White Rose Carbon Capture and Storage (CCS) Project

Document Ref: 9.3
PINS Ref: EN10048

The White Rose CCS (Generating Station) Order

Applicant's Comments on the Local Impact Report, Responses to the Examining Authority's First Written Questions and Written Representations

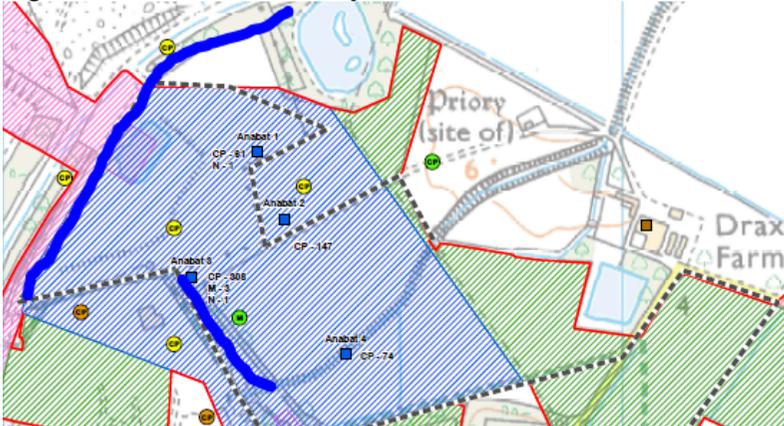
Ref.	Interested Party/Document	Section, page and/or paragraph no.	Issue/Matter	Applicant's Comments
				further.
31	NYCC/SDC – Local Impact Report	Section 9, Paragraph 9.6	Ecology: Flood attenuation pond	The LIR has indicated a preference for the flood attenuation pond to be designed so that pumping water from the Carr Dyke would be unnecessary. Detailed design work will form part of the development of the Indicative Landscaping and Biodiversity Framework Plan (Document Ref. 4.10).
32	NYCC/SDC – Local Impact Report	Section 9, Paragraph 9.7	Ecology: Bat foraging	<p>The LIR states; <i>“The key impact is a loss of foraging habitat and loss of connectivity with Barlow Mound – the key mitigation is noted as “maintain scrub/plantation which runs along the fence line in the centre of the Operational Area (Table 4.1)”.</i></p> <p>There is no key impact. Impacts on bats were assessed as non-significant. Unsurprisingly given the largely open and generally intensive arable habitat only common and widespread species were encountered in low numbers. Bats were shown to favour the area around Drax Abbey farm (with its large pond fringed by mature woodland) and the network of woodland, scrub and grassland created on Barlow Mound. A commuting corridor between Drax Abbey farm, the ecological pond created by Drax, and the habitats on Barlow Mound exists in the form of patches of scrub and shelter belt. This will be retained as far as is reasonably practicable and is shown as the long blue line in Figure 1 below</p> <p>A line of scattered scrub along the edge of arable crops and improved grassland is unlikely to be retained. This is shown as the smaller blue line ending at Carr Dyke.</p>

Ref.	Interested Party/Document	Section, page and/or paragraph no.	Issue/Matter	Applicant's Comments
				<p>Figure 1 Scrub lines used by bats</p>  <p>Although impacts on bats are non-significant the Indicative Landscaping and Biodiversity Framework Plan (Document ref: 4.10) includes provision for lines and clusters of trees and scrub connecting the perimeter of the site with the wider landscape. This will create new commuting opportunities for bat populations. The creation of species rich grassland and provision of a pond will provide foraging opportunities connected to these commuting lines. This represents an ecological benefit.</p>
33	NYCC/SDC – Local Impact Report	Section 9, Paragraph 9.8	Ecology: Grass Snake	The LIR raises concern about the loss of 10ha of potentially suitable habitat for grass snake. It should be noted that habitat suitability on the site is relatively limited, and this was reflected by the fact that a
